DOCKETED	
Docket Number:	11-AFC-04
Project Title:	Rio Mesa Solar Electric
TN #:	233564
Document Title:	Applicant's Supplemental Response to Data Request 16 and 26 Additional Information Regarding Land Use
Description:	Document was on proceeding webpage and is now moved over to the docket log.
Filer:	Marichka Haws
Organization:	California Energy Commission
Submitter Role:	Commission Staff
Submission Date:	6/19/2020 3:35:41 PM
Docketed Date:	6/19/2020

APPLICANT’S SUPPLEMENTAL RESPONSE TO DATA REQUEST 16 AND 26: ADDITIONAL INFORMATION REGARDING LAND USE

CREATED BY: CM	DATE: 7/5/2012	FIG. NO: 5.6-1
PM: AL	PROJ. NO: 27651003.40010	(REV)

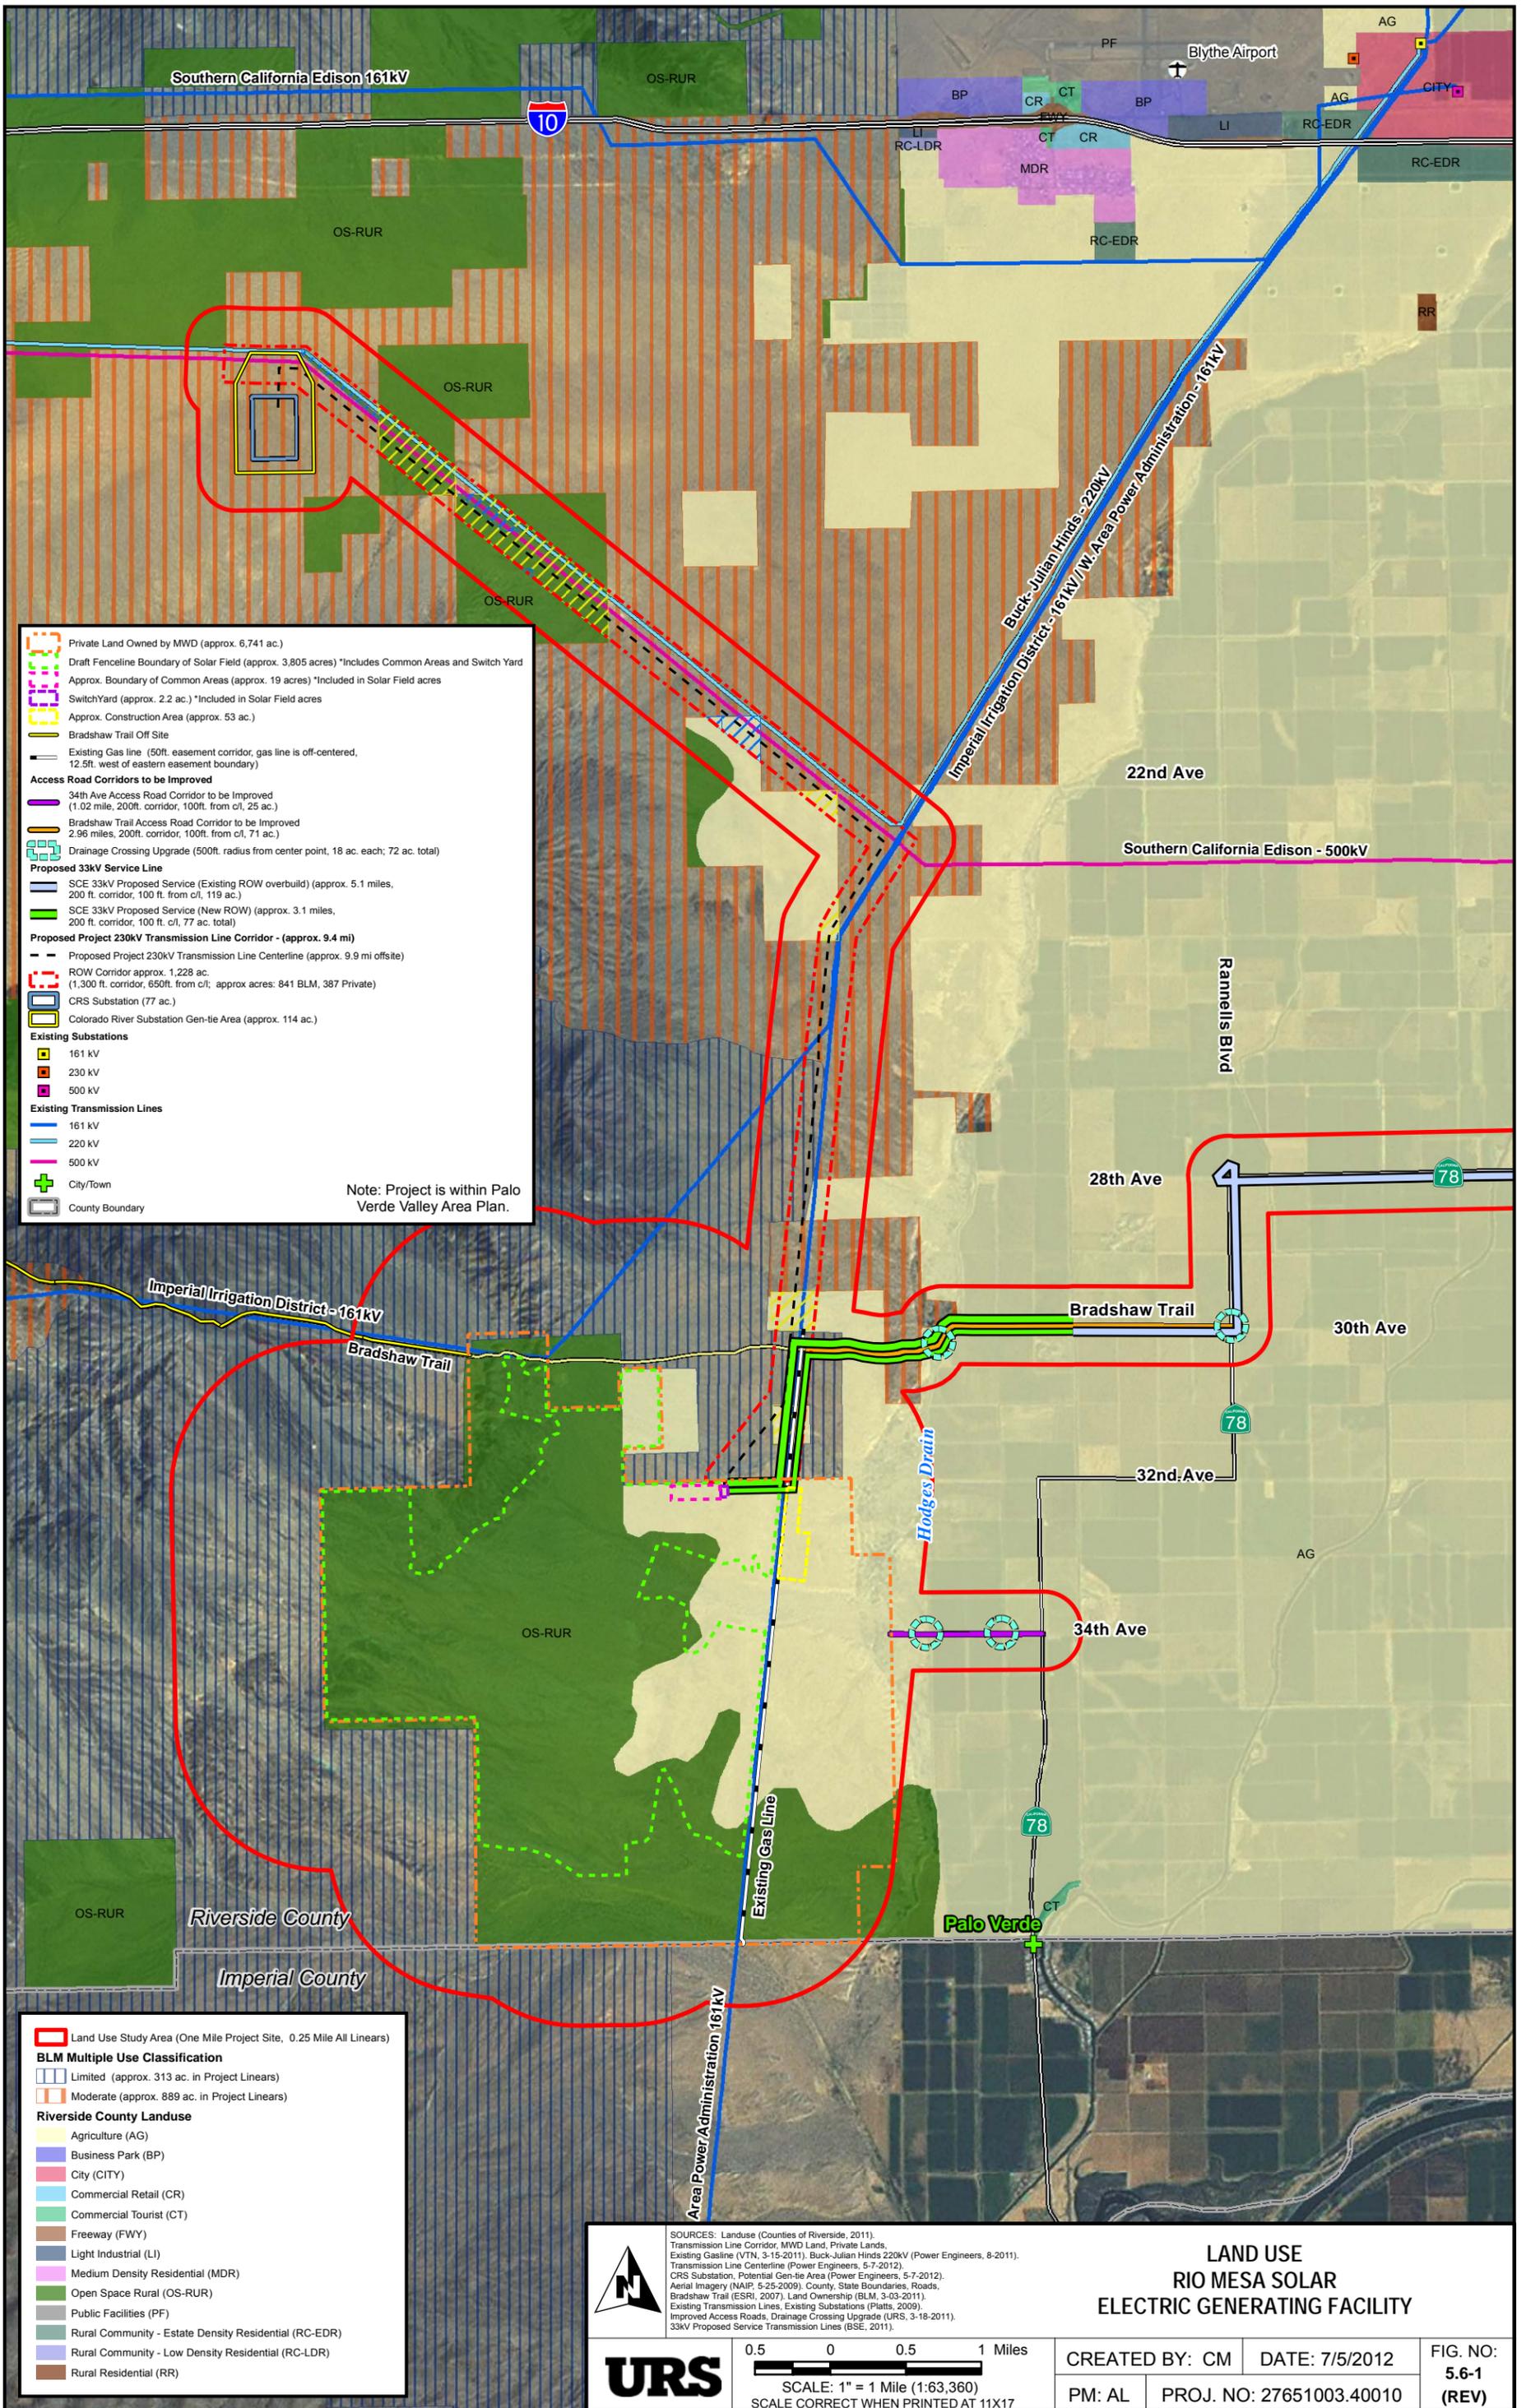
The CDCA Plan organizes BLM-managed lands into one of four multiple-use class (MUC) designations: Controlled Use (C), Limited Use (L), Moderate Use (M), and Intensive Use (I). [The gen-tie line, 33 kV construction/emergency backup power supply line, and access road corridors to be improved](#)~~The project site and linear features~~, with the exception of privately-owned parcels, are designated MUC-L and MUC-M (see Figure 5.6-1 [\(rev\)](#)).

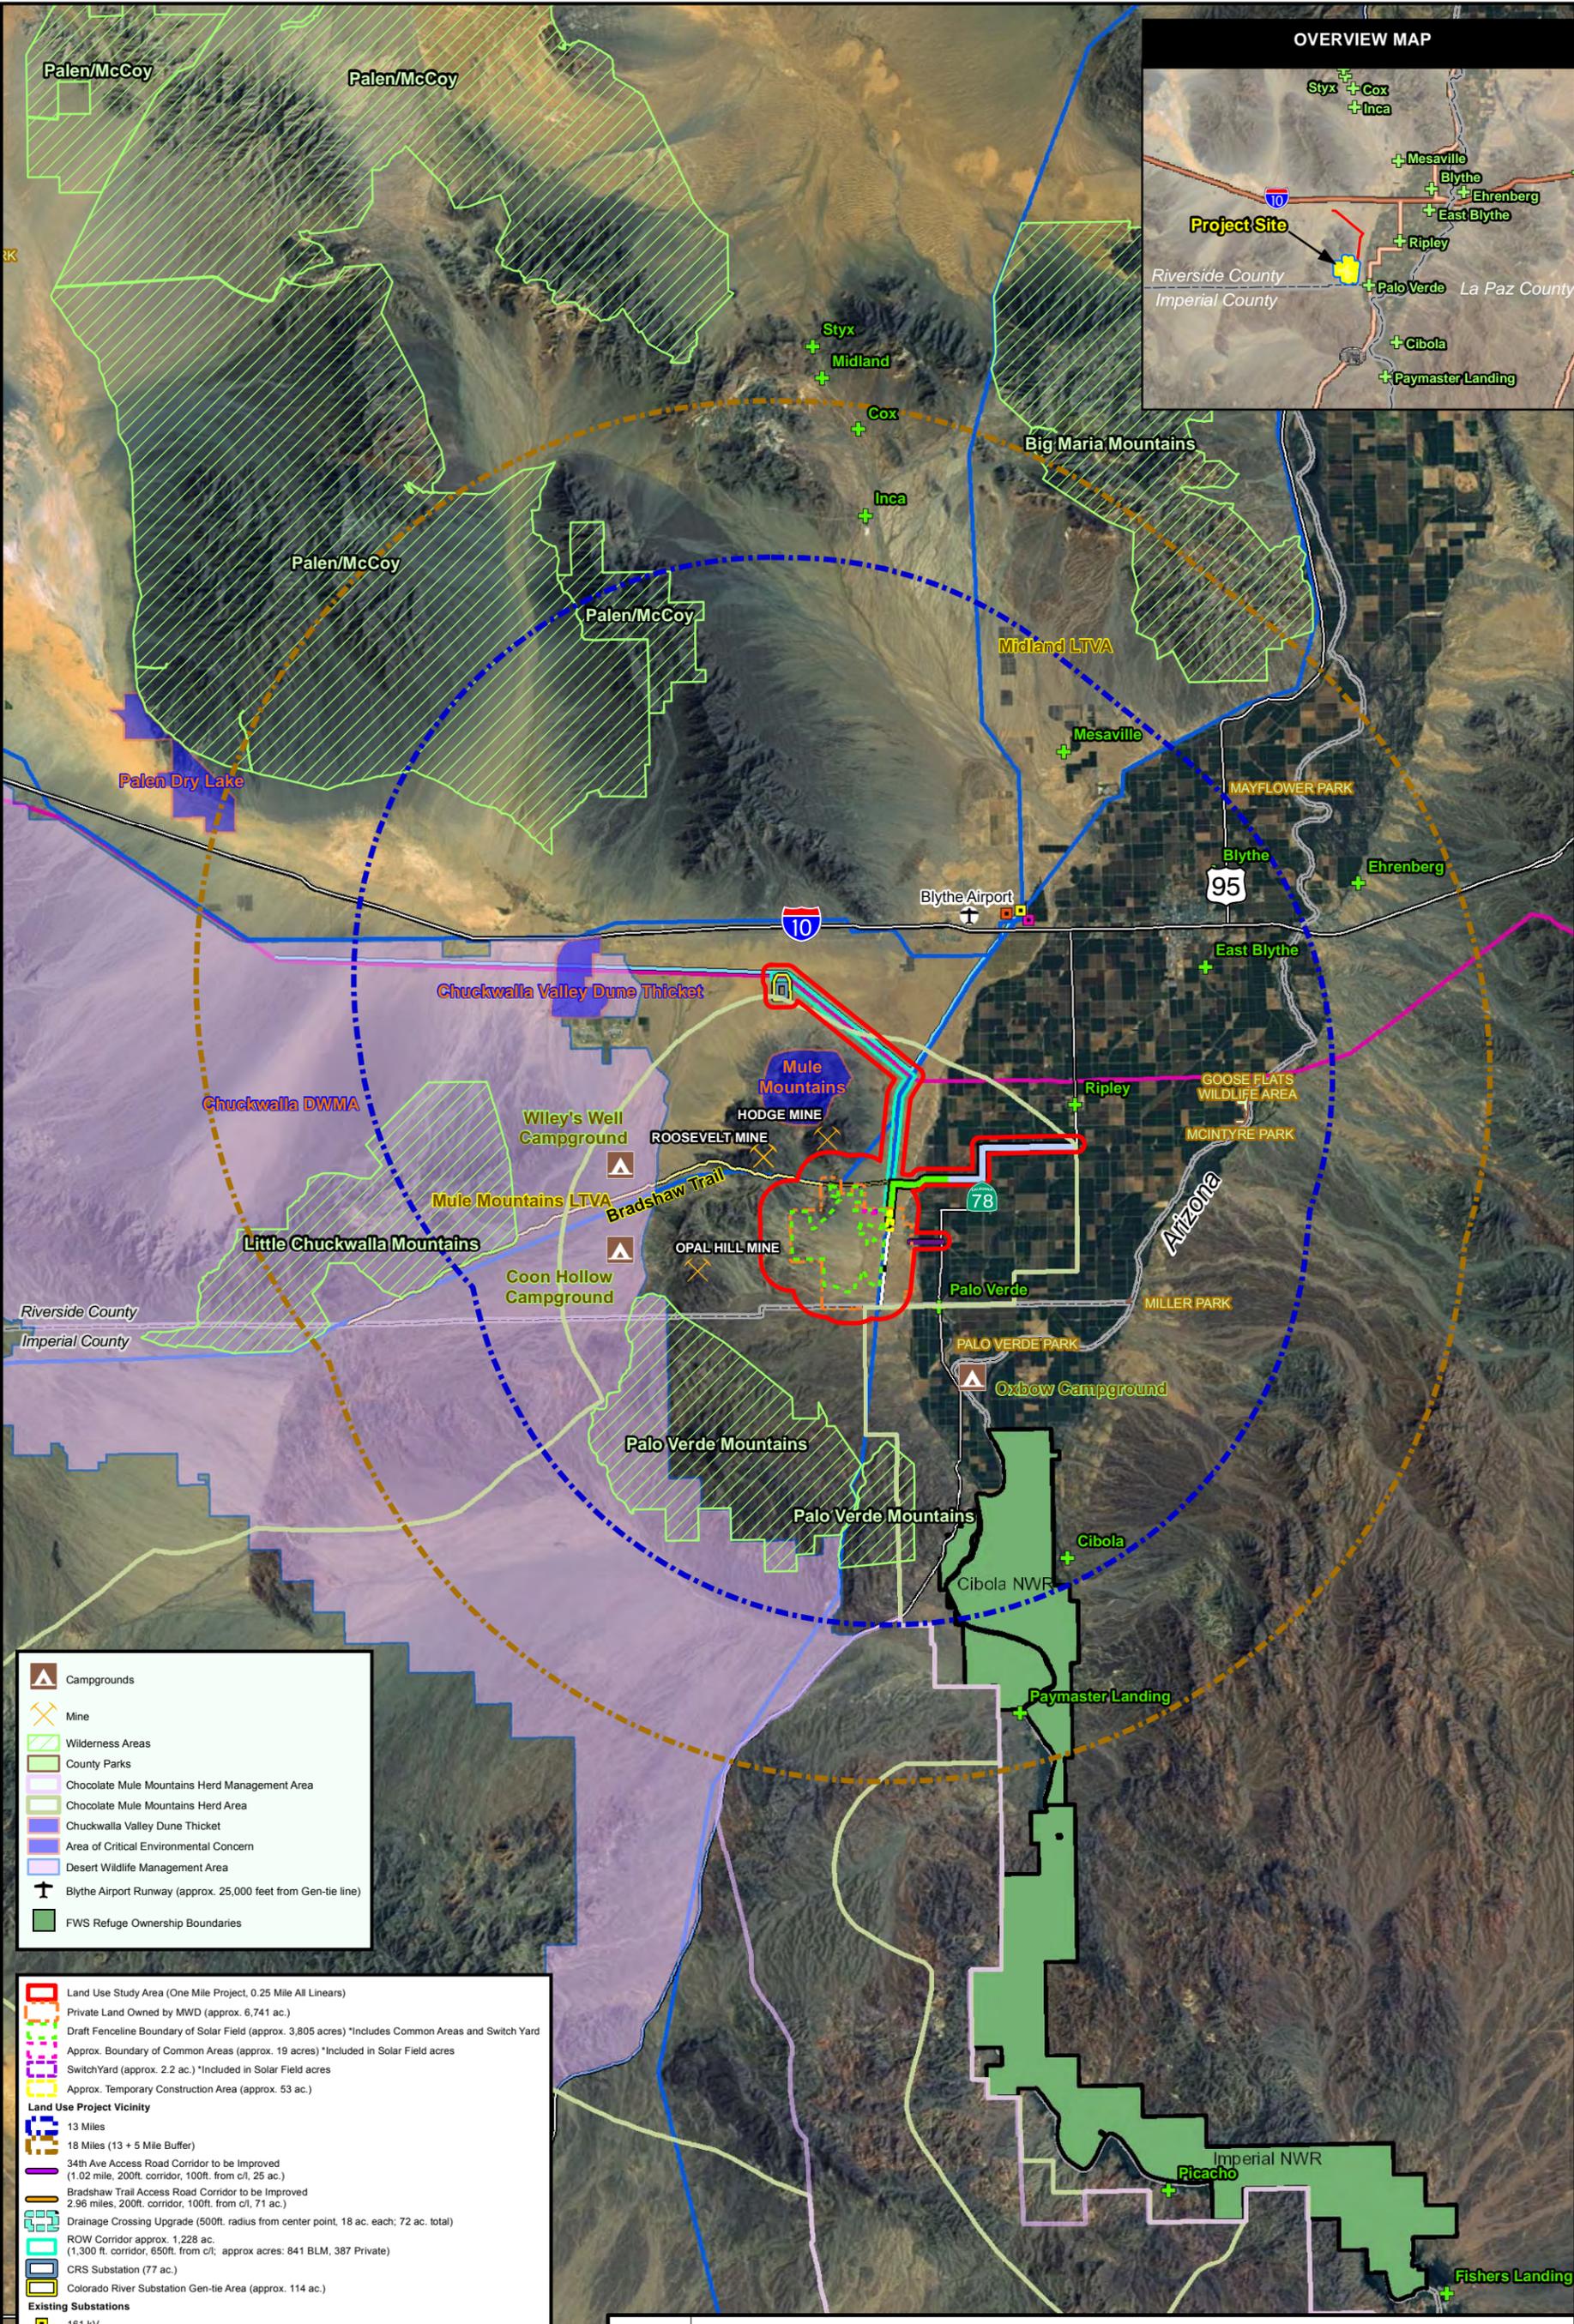
The project Study Area is located in unincorporated eastern Riverside County approximately 13 miles southwest of Blythe, California. The Study Area is located on the southeastern extent of the large Southern Recovery Unit for desert tortoise (NECO Map 1-2). The BLM has identified two federally-listed species affected by the CDCA Plan in the NECO Planning Area: the desert tortoise (*Gopherus agassizii*) and the Coachella milkvetch (*Atragalus lentiginosus* var. *coachellae*). Special-status wildlife and plant species are discussed in Section 5.2, Biological Resources. The Study Area is not subject to a Habitat Conservation Plan or Natural Community Conservation Plan or located within the boundaries of a wildlife preserve. The Study Area is located within the draft Desert Renewable Energy Conservation Plan area. The Chuckwalla DWMA is approximately four miles west of the Study Area. According to NECO Map 2-4, the Mule Mountains ACEC is outside of the Study Area, approximately 0.8 miles west and southwest of the transmission line (BLM, 2002) (see Figure 5.6-2 [rev](#)).

As discussed previously, the Project is located within the Chocolate-Mule Mountains HA. The project site will be fenced, closing off a portion of this HA (see Figure 5.6-2 [\(rev\)](#)). However, the closing of this portion of the HA is not anticipated to cause a significant impact. The Chocolate-Mule Mountains HMA is approximately 10 miles south of the project site. The Project will result in a finding of no impact to the HMA.
